SUBJECT: SYSTEMATIC EVALUATION PROGRAM (SEP) FOR THE LACROSSE
BOILING WATER REACTOR - EVALUATION REPORT ON TOPICS
VI-2.D AND VI-3

SAFETY EVALUATION REPORT
ON
CONTAINMENT PRESSURE AND
HEAT REMOVAL CAPABILITY
SEP TOPIC VI-3
AND
MASS AND ENERGY RELEASE
FOR POSSIBLE PIPE BREAK
INSIDE CONTAINMENT,
SEP TOPIC VI-2.D
FOR THE
LACROSSE NUCLEAR POWER PLANT

SEP Containment Analysis and Evaluation
for the La Crosse Nuclear Power Plant

Figure 1. Containment Pressure Response to a 3.59 sq. ft. Cold Leg Discharge Break

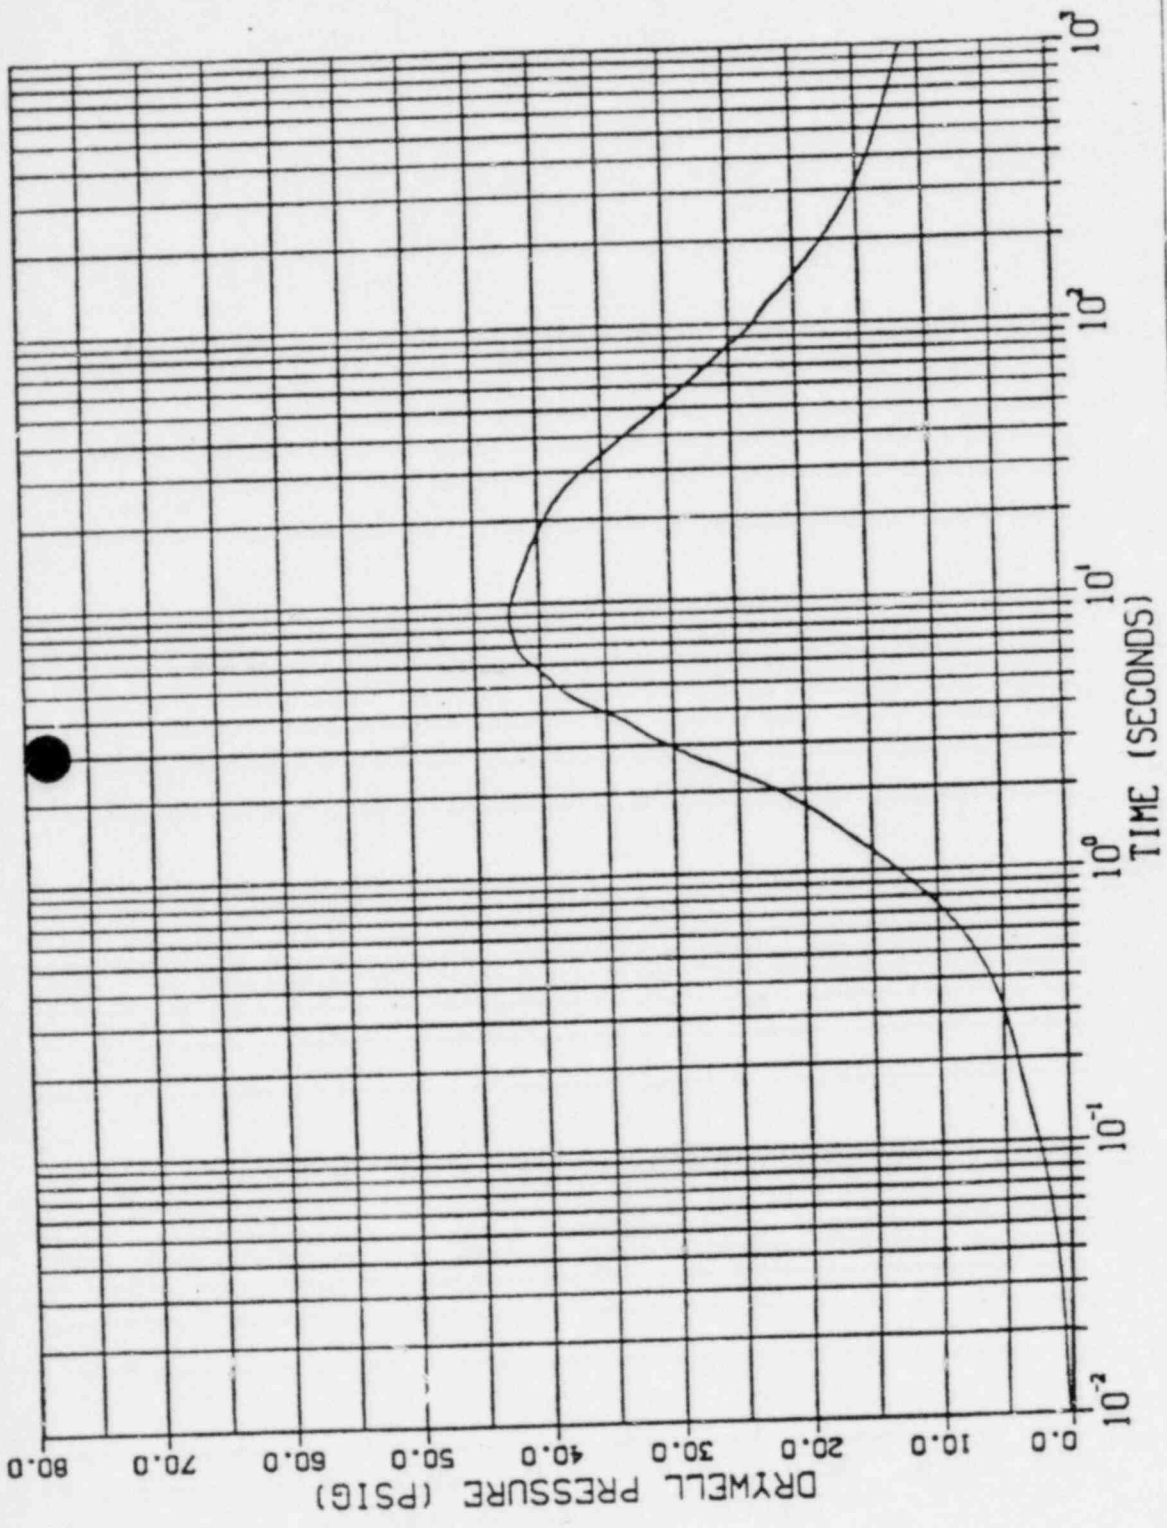
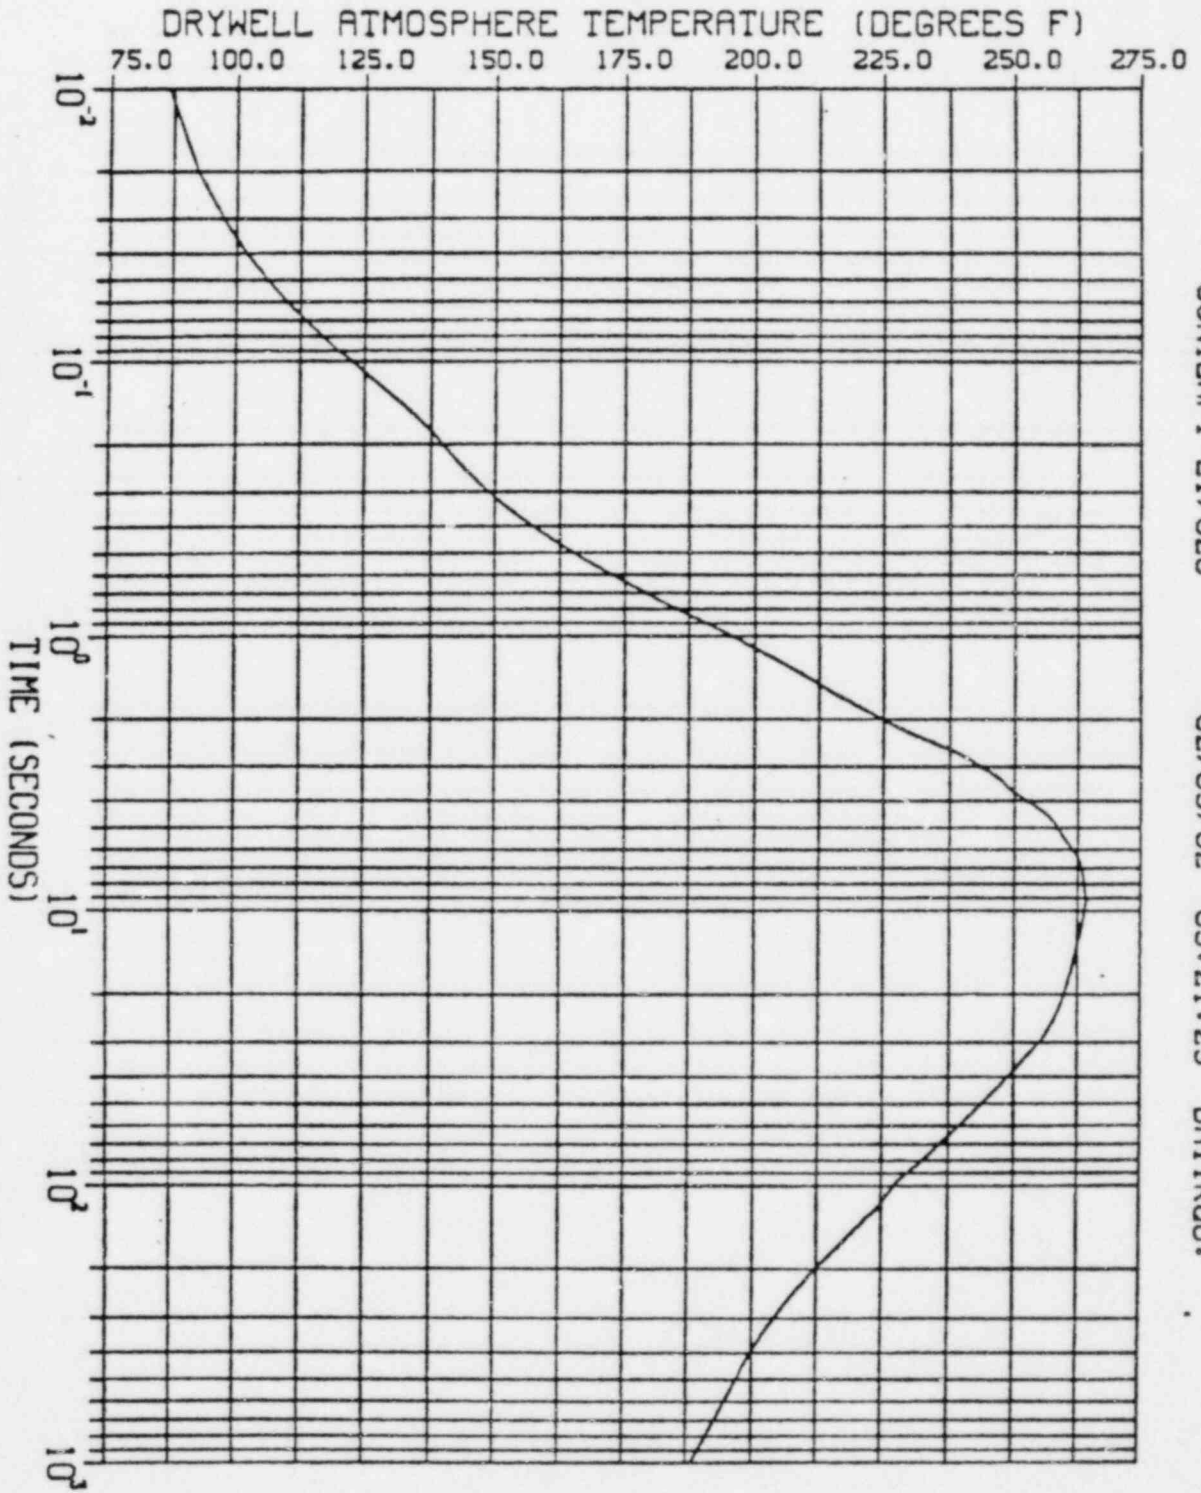
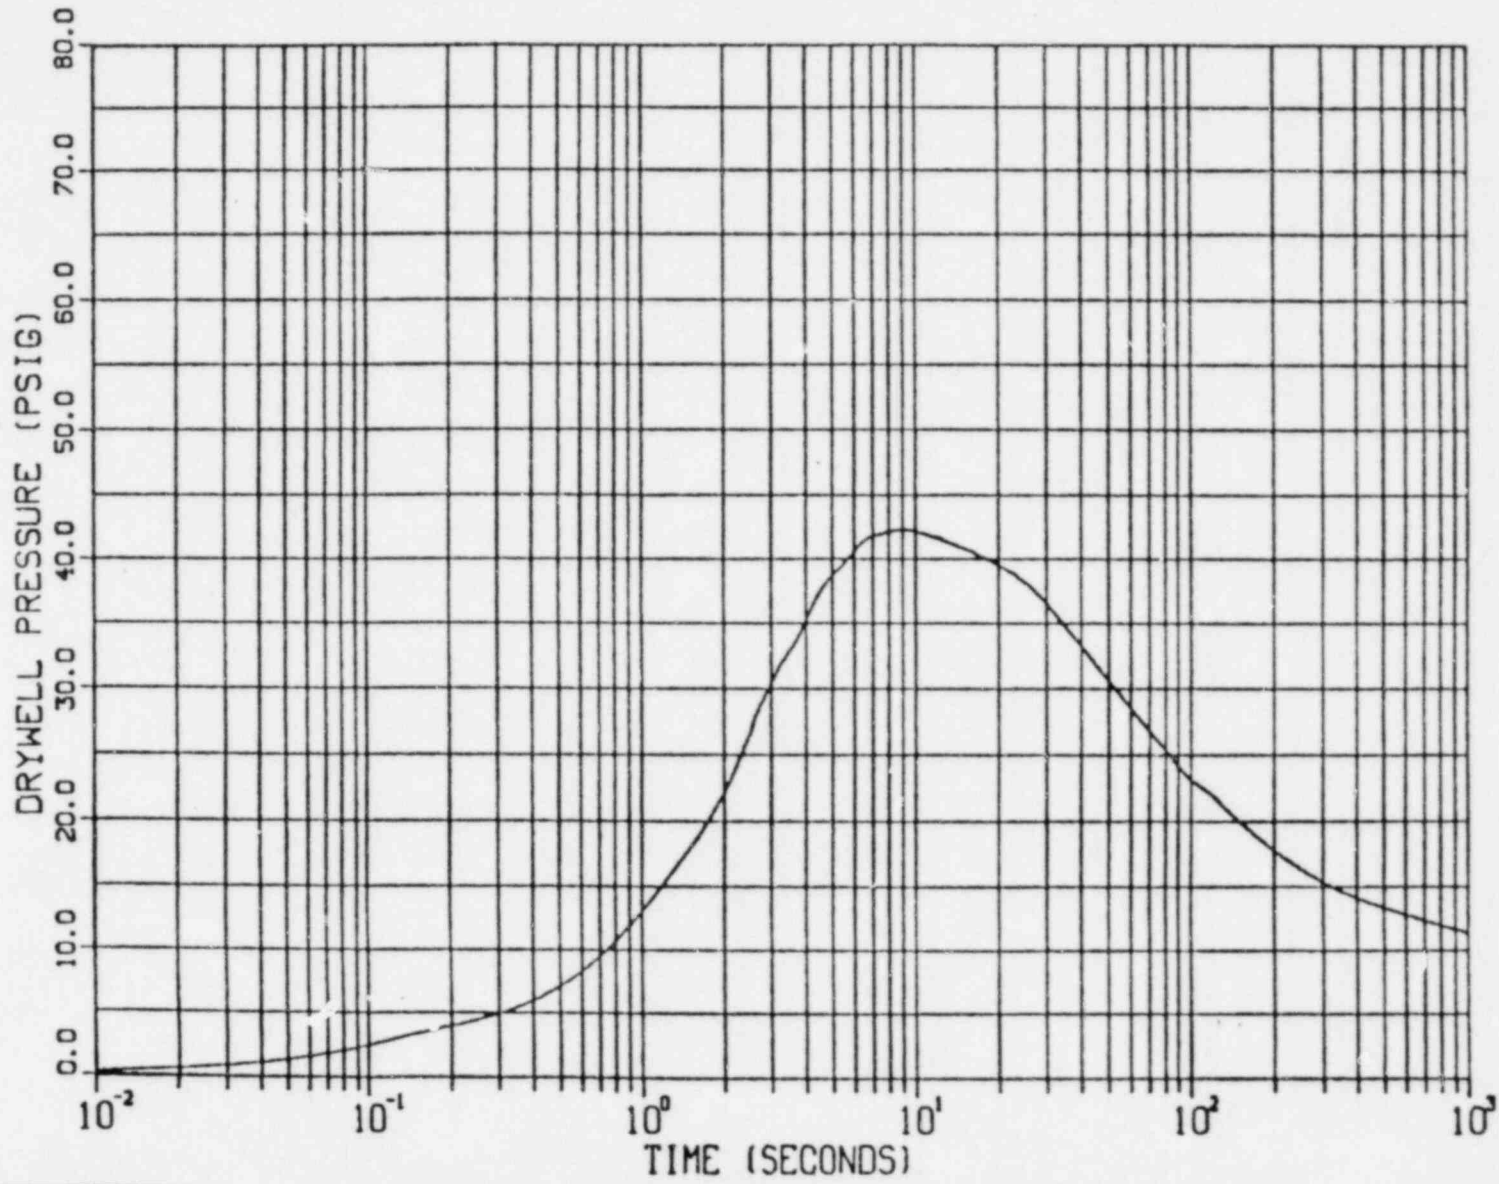
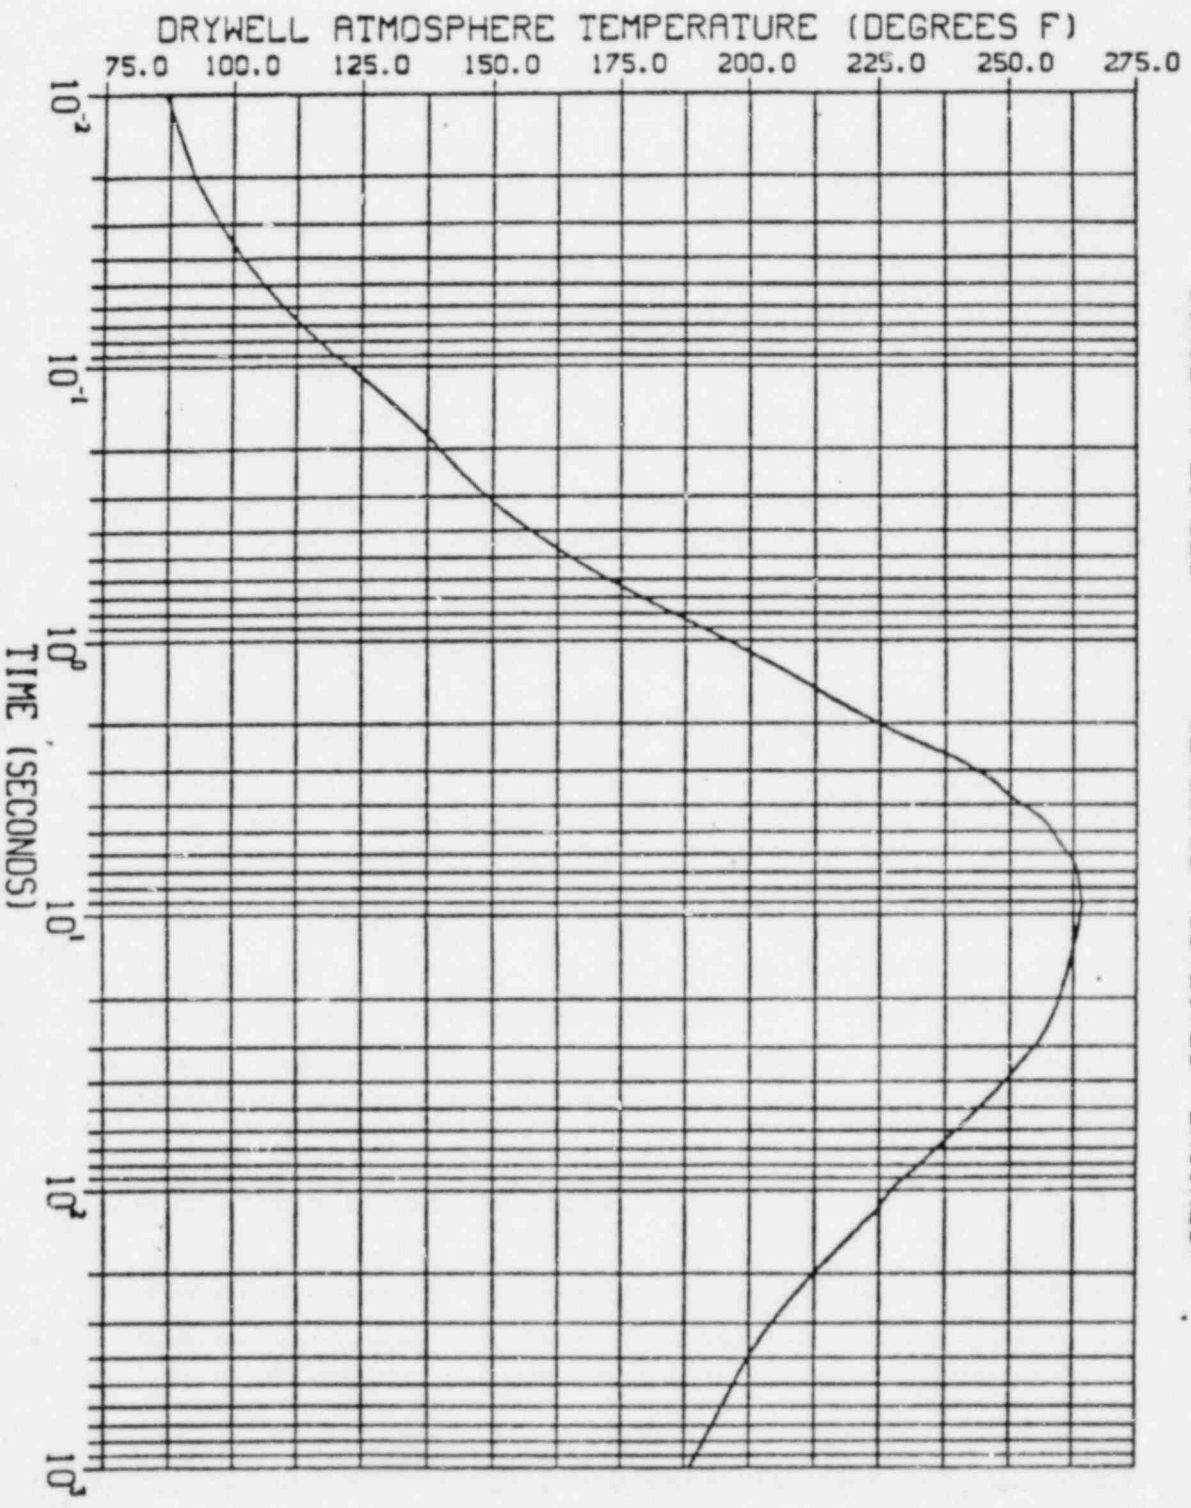
The containment pressure and temperature response to a recirculation line break are shown in Figures 1 and 2. The calculated transient reflects a peak post-accident containment pressure of 43 psig and a temperature of 270°F. This compares with a containment pressure of 48.2 psig calculated by Dairyland Power Cooperative presented in the FHSR for La Crosse. The containment design pressure is 52 psig. There is, therefore, an 8% margin between the peak calculated pressure and the containment design pressure.
